Product Change Notice (PCN)

PCN Number: **PCN-0450915R-01**

Product(s) Affected: *SJ1-2513-SMT-TR & SJ1-2515-SMT-TR*

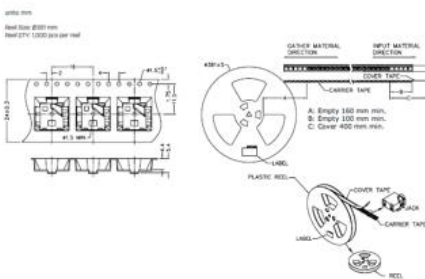
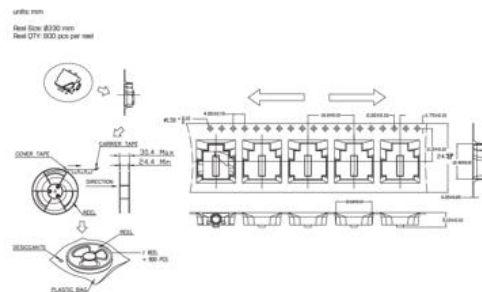
Description of Change: *Minor Housing and footprint differences. Material Change on the housing and terminals. See image Below*
